Agenda Item #3

Application 2024-12-CA

262 Marine Street

Alterations to front porch

1. East facade, looking southwest

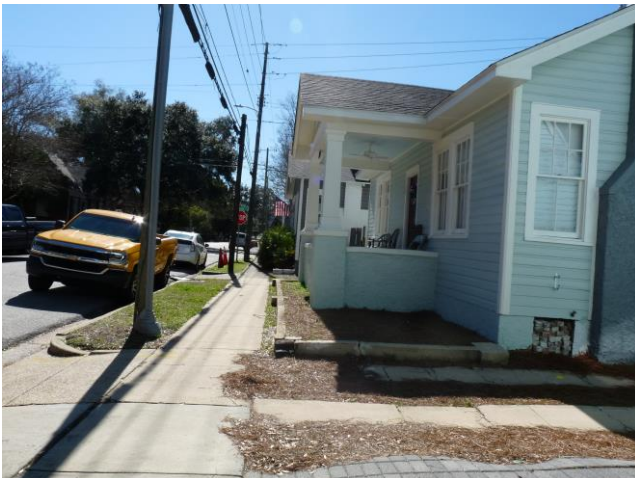
The submitted alterations and additions would match the existing front porch in both materials and design. The *Guidelines* mention that original front steps should not be relocated. (6.6) In the case of the subject property, the existing steps are located behind a low knee wall, obstructing their visibility from the street. The proposed new steps on the north end of the porch would likewise be located behind a knee wall. The intentional concealment of the front steps is inherent to the design of the structure and therefore their relocation does not impact the porch design in the same way as that of a visible stairway.

4. View of south end of front porch/facade

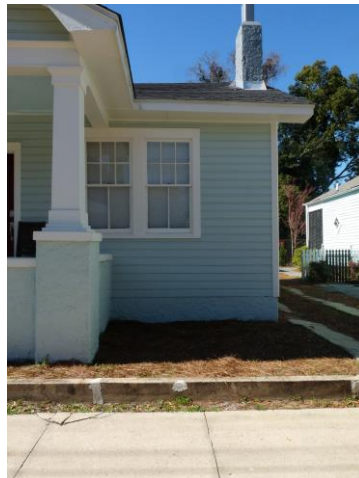
- a. An extension of the concrete porch floor measuring approximately 7'-0" wide by 6'-0" deep (to match the depth of the existing 16'-0" wide porch) would occupy the footprint of the existing porch steps on the south end of the porch. The porch floor extension would match the floor height of the existing front porch.

- b. A new 15"-deep stuccoed knee wall, which would match the existing in height, depth, and profile, would enclose the extension on the east and south.
